FINAL
DRAFT
SUMMARY OF FINDINGS
ON
REMAINING SEGMENTS OF TUNNEL AND RESERVOIR PROJECT
AND
METROPOLITAN SANITARY DISTRICT
OF GREATER CHICAGO
ADVANCED TREATMENT FACILITIES
PROPOSED FOR
METROPOLITAN SANITARY DISTRICT OF GREATER CHICAGO

ENVIRONMENTAL PROTECTION AGENCY
ADVANCED TREATMENT TASK FORCE

August 1980

This report reviews the Tunnel and Reservoir Plan (TARP) and advanced secondary treatment plants of the Metropolitan Sanitary District of Greater Chicago (MSDGC). Only unfunded segments of TARP and the treatment plant projects were reviewed.

Fig. V-8-3 CALUMET PROPOSED PROCESS FLOW DIAGRAM

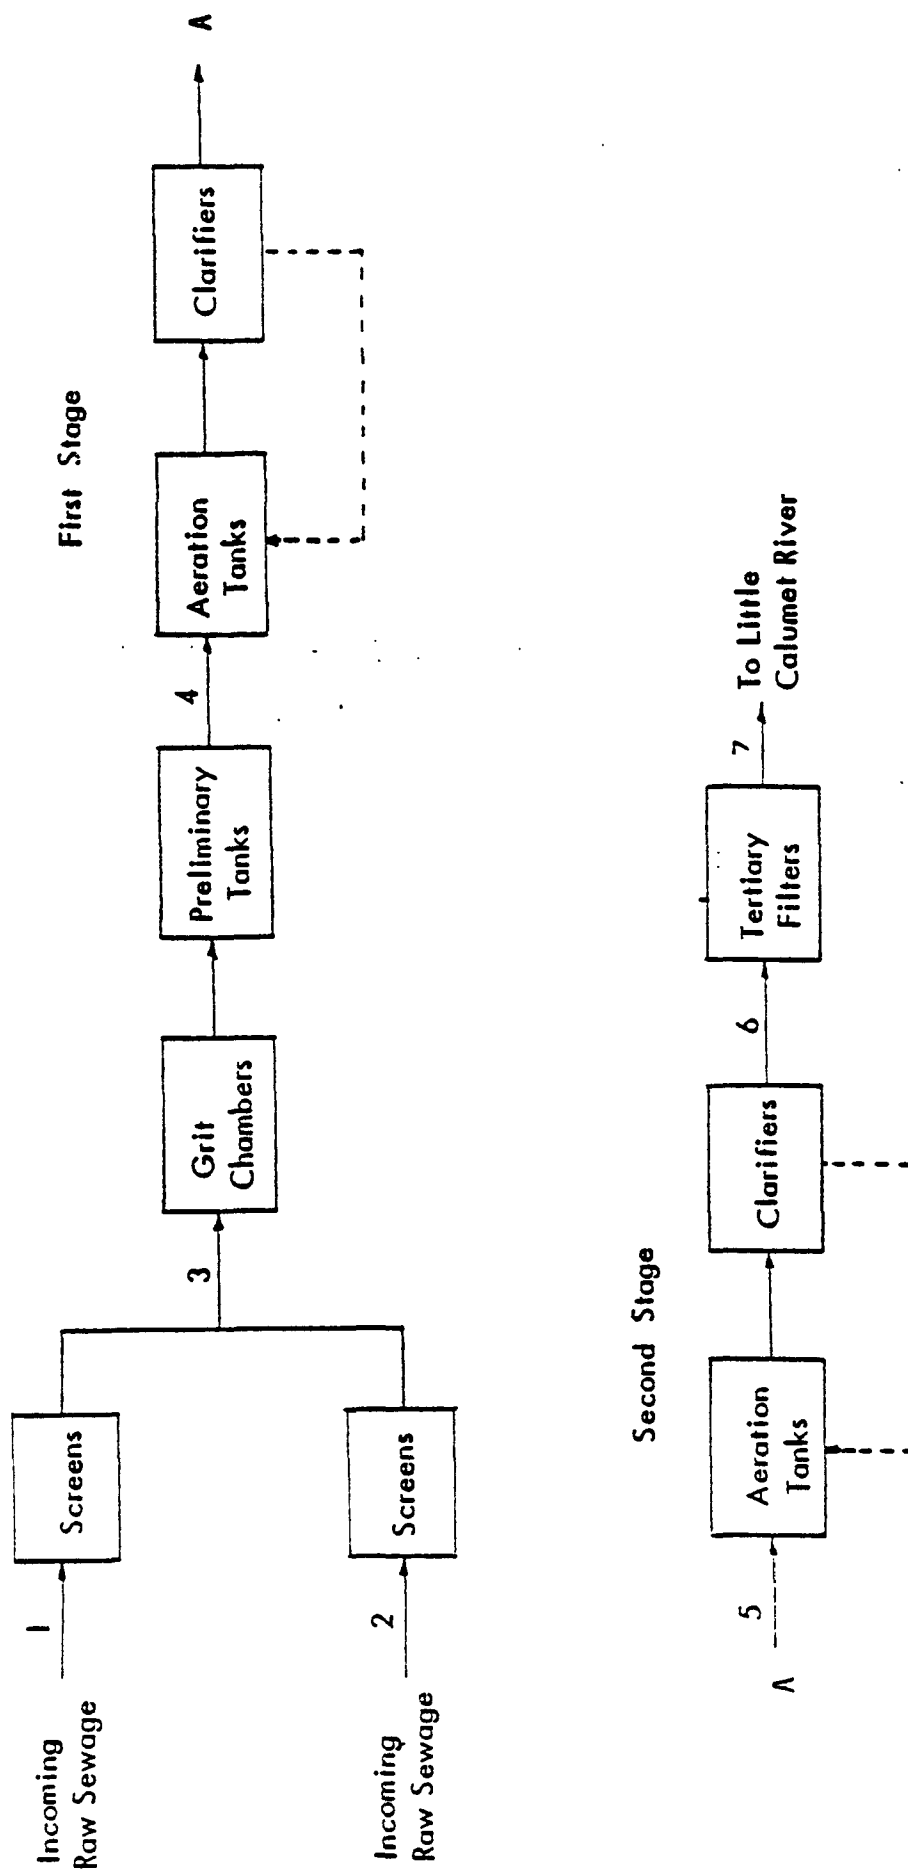
- Facility will be upgraded to two-stage nitrification; this will be accomplished by expanding the existing capacity of the secondary treatment facility from 220 MGD to 354 MGD, and by adding a new 354 MGD second-stage nitrification facility. In addition, tertiary filtration of nitrified effluent is also proposed, but the amount of flow to be filtered is not specified pending completion of a pilot plant study. Also, capacity of primary clarifiers to be expanded from 220 MGD to 354 MGD.
- Design effluent limitations are:

BOD ₅	10 mg/l	(30 days average)
SS	12 mg/l	(30 days average)
NH ₃ -N	2.5 mg/l	April-October
	4.0 mg/l	all other times
- Proposed process flow diagram is shown in Figure V-8-3 (accompanying Table V-8-3-a shows the wastewater quality at significant points in the treatment train).
- Proposed design flow conditions for the year 1990 and design population 1,140,800 (NIPC) are summarized in Table V-8-3-b.

TARP REVIEW - REMAINING PHASE I

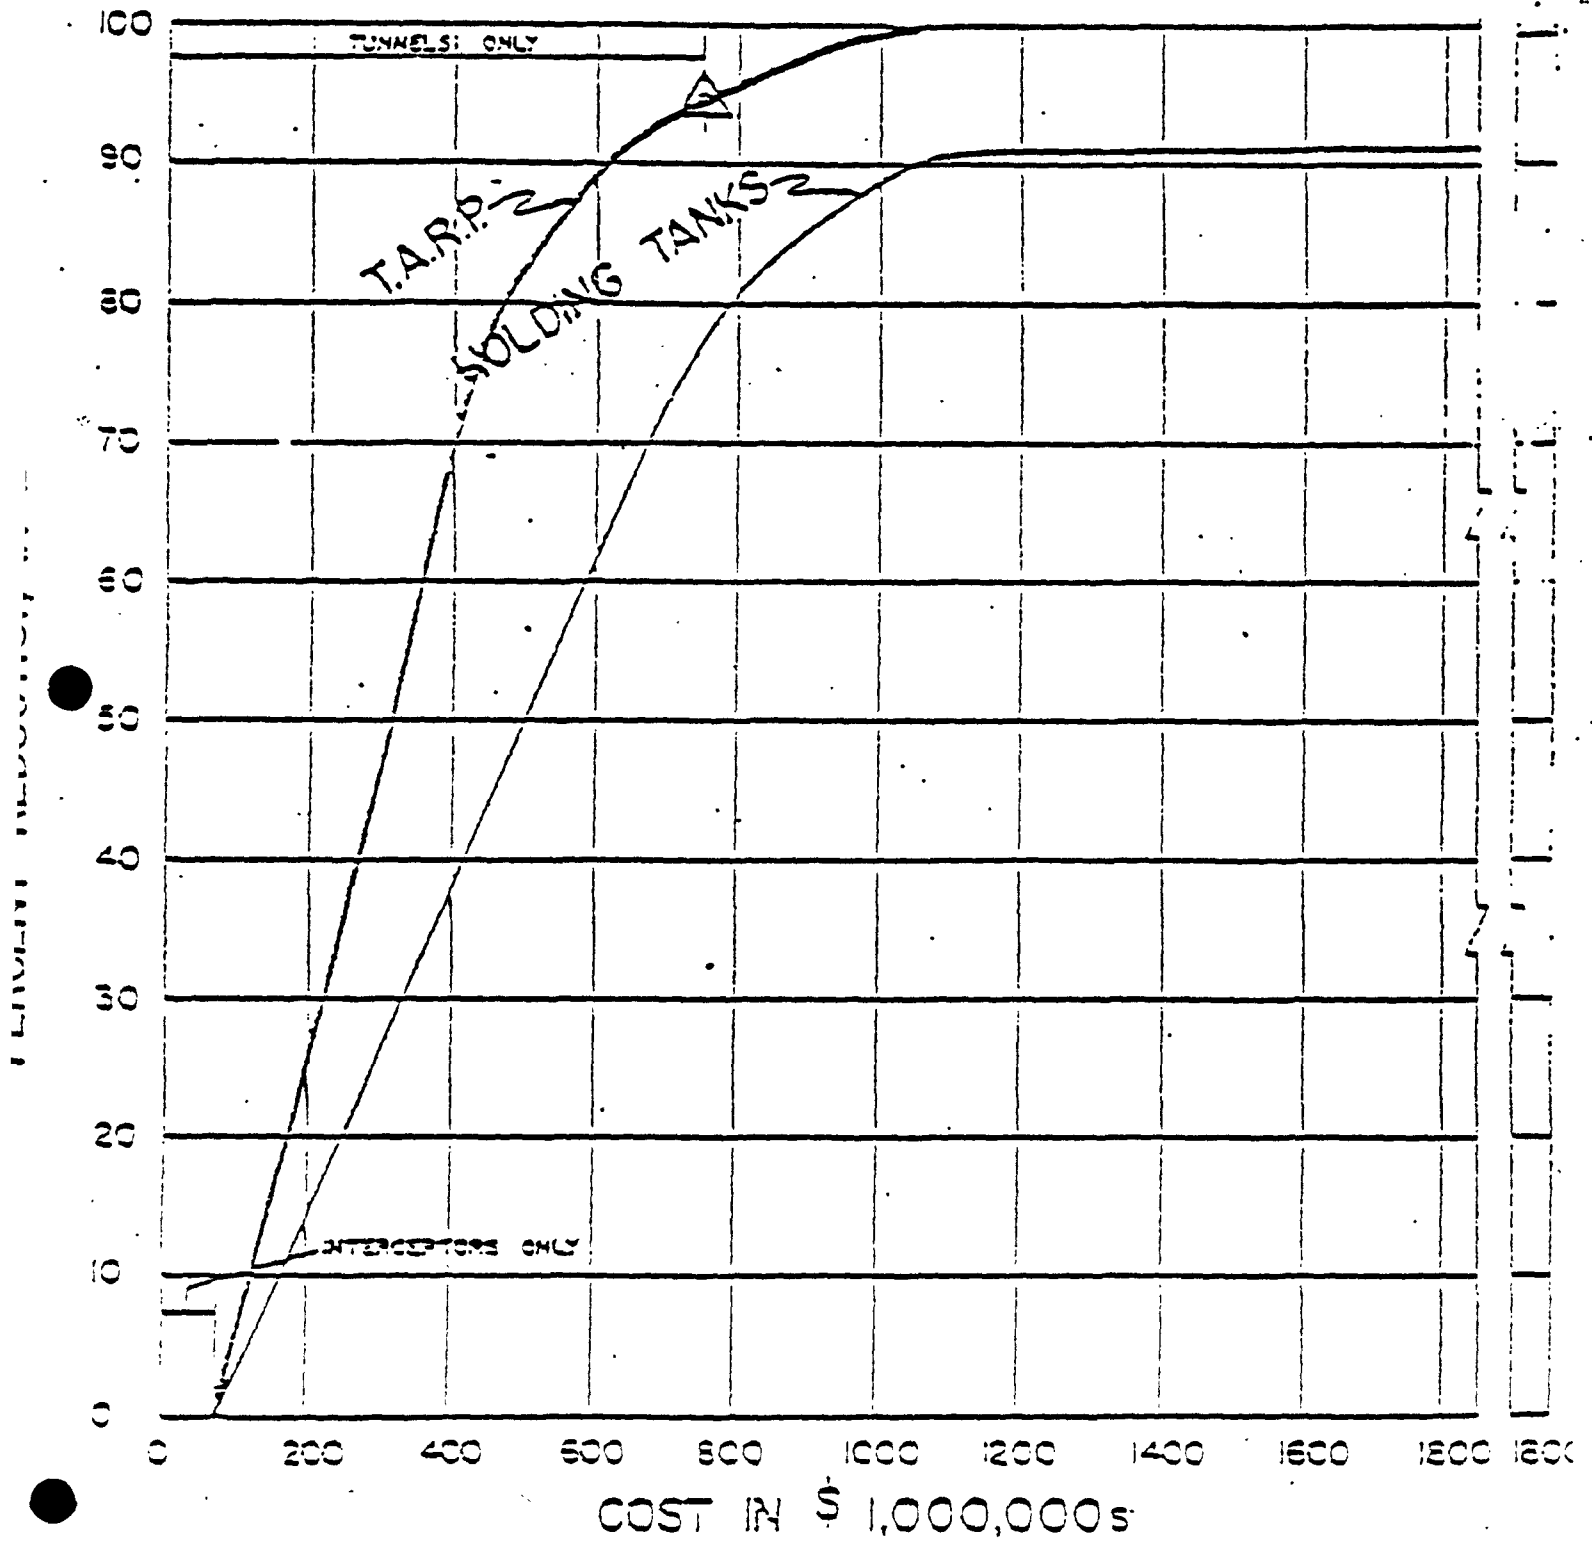
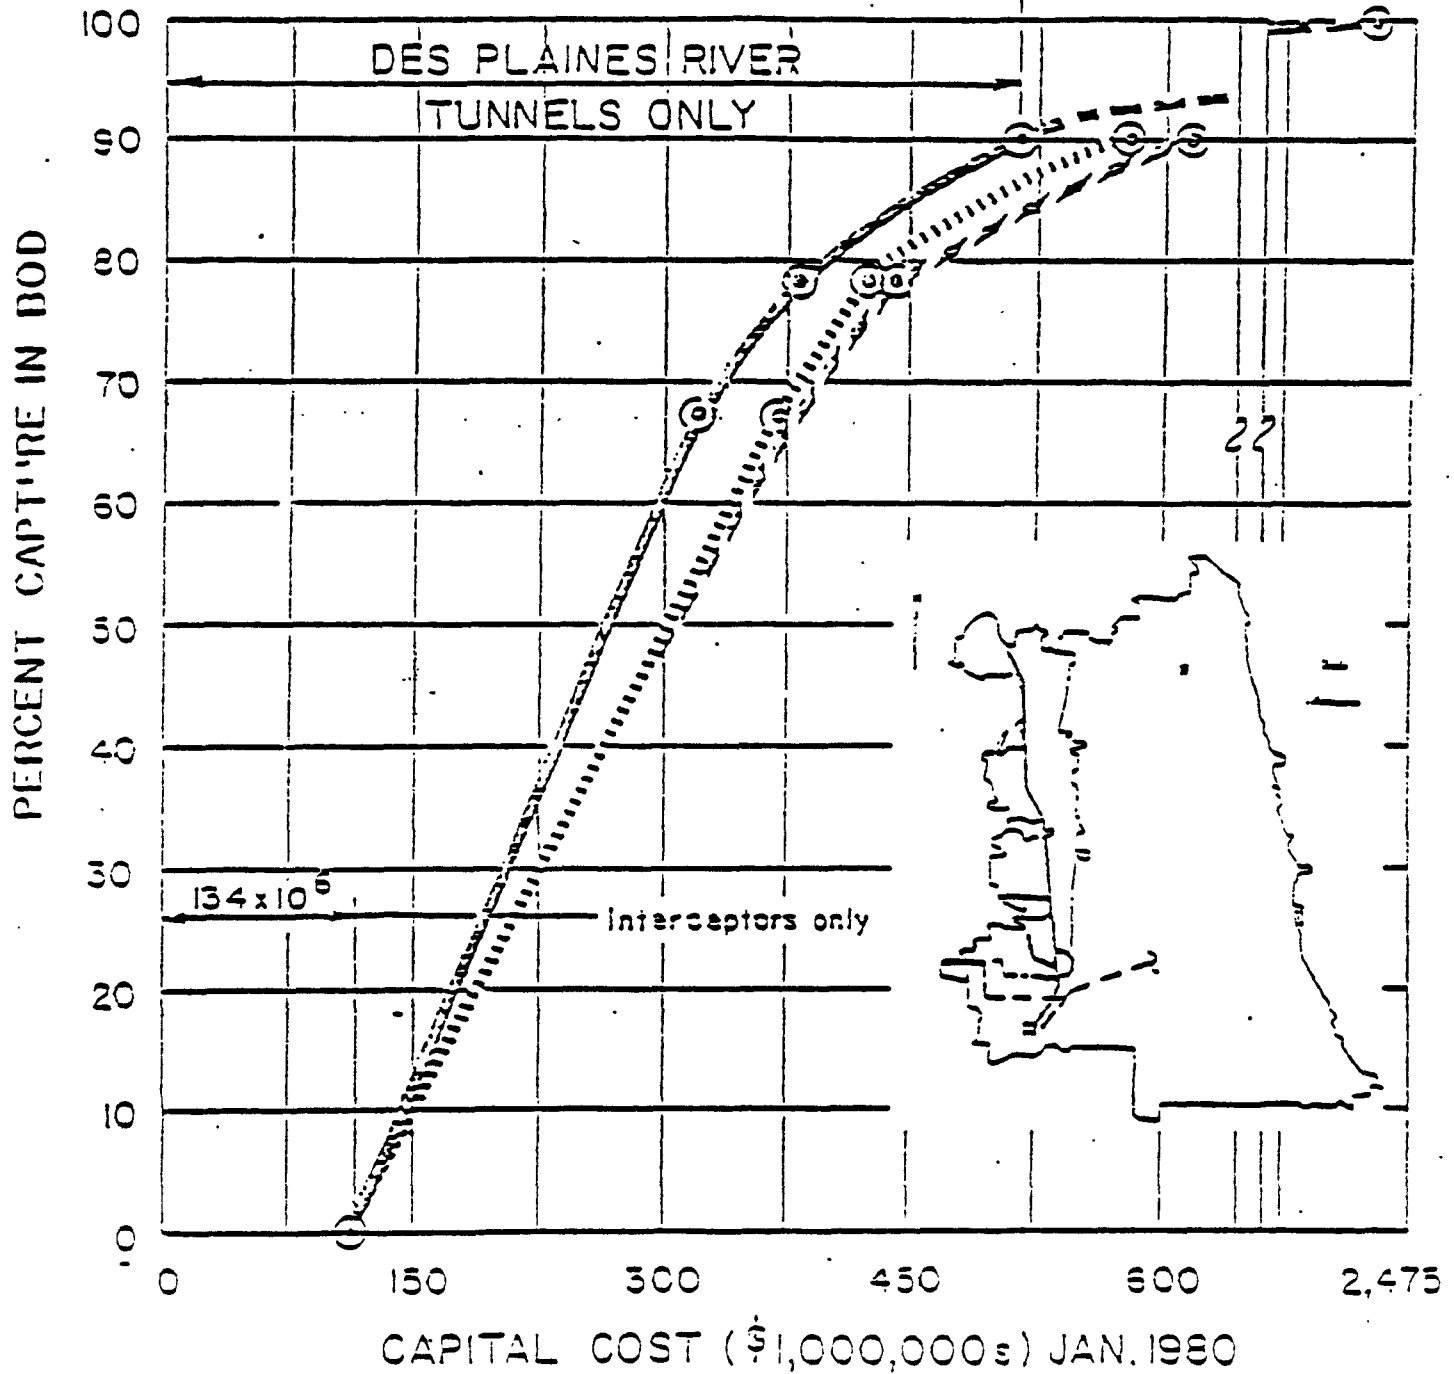
- "Knee of the curve" analysis shows that proposed level of control is appropriate. (See Figure VI-1.)
- Based on above considerations, the level of control provided by TARP Phase I is justified.

- "Knee of the curve" analyses for Des Plaines River show that the proposed level of control is justified. (See Figure VI-2.)

FIGURE 2

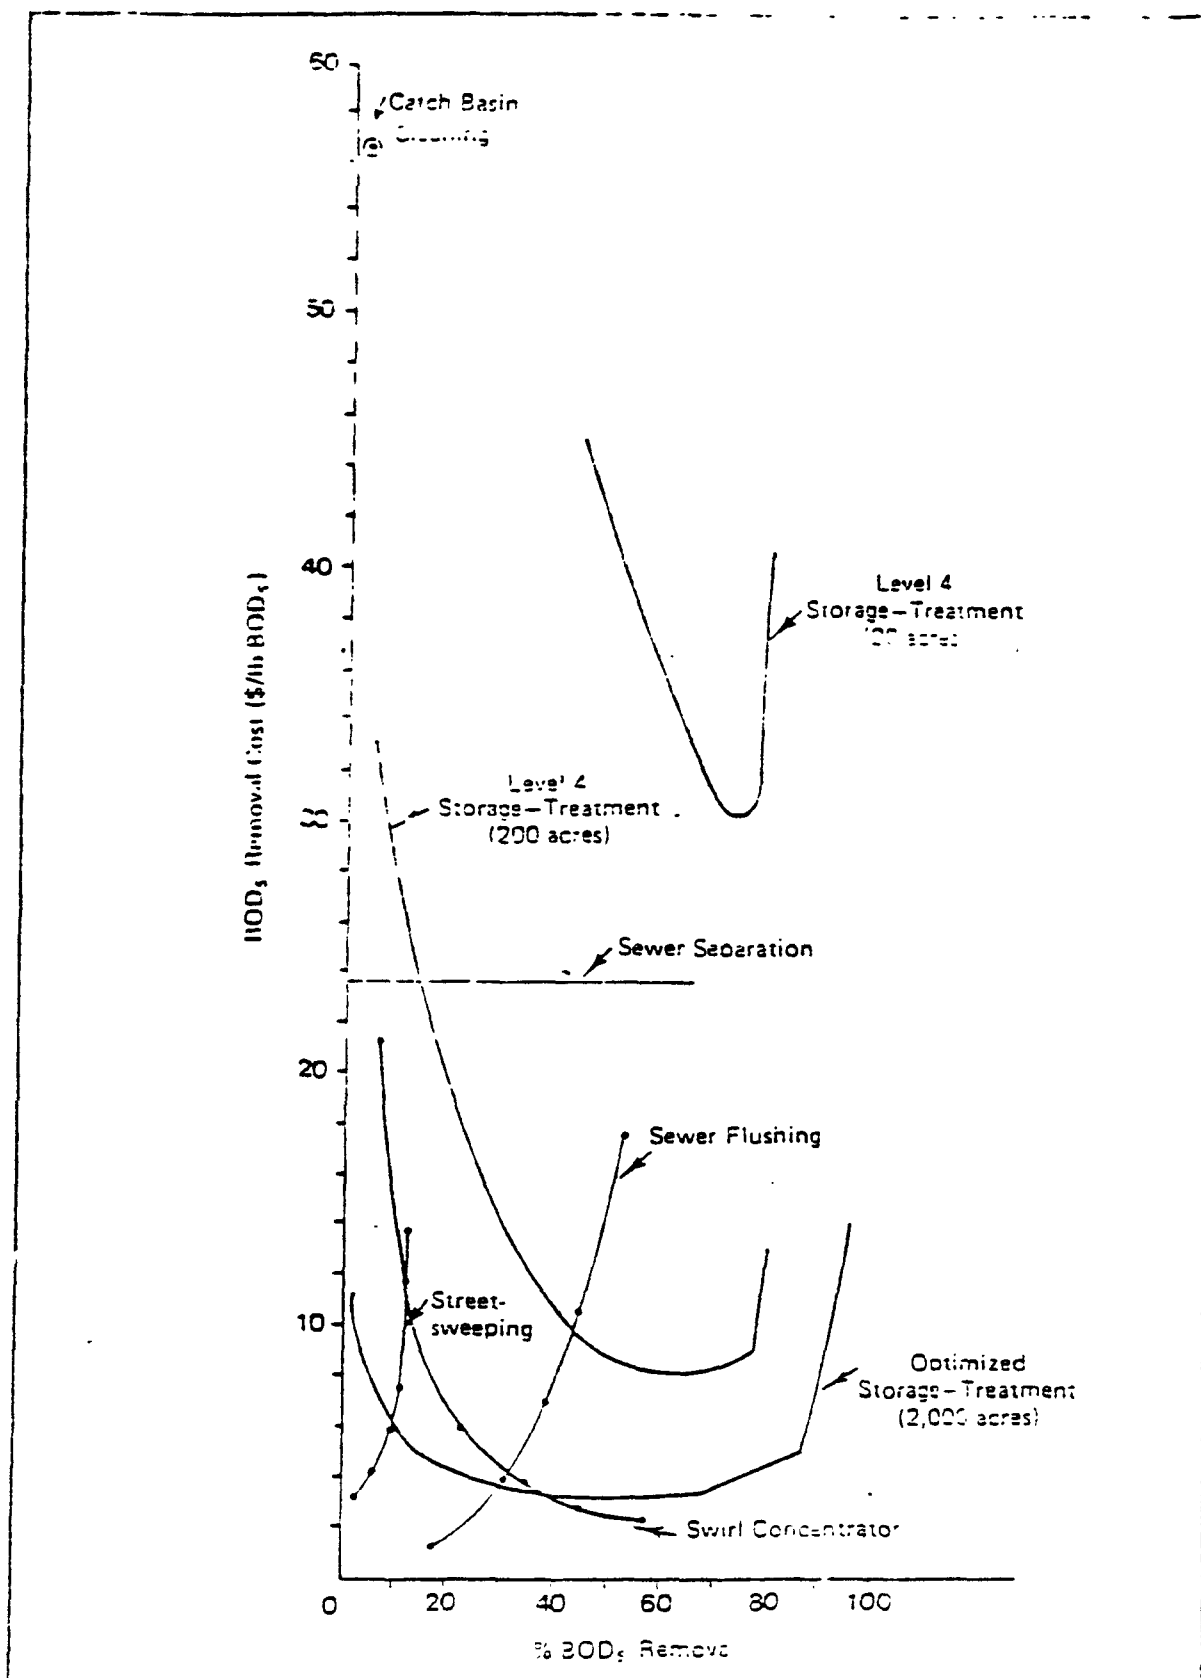
- o streetcleaning has been evaluated and found to be inadequate for pollution control (see Figure 2);
- o devices for preventing basement flooding have limited water quality improvement benefits;
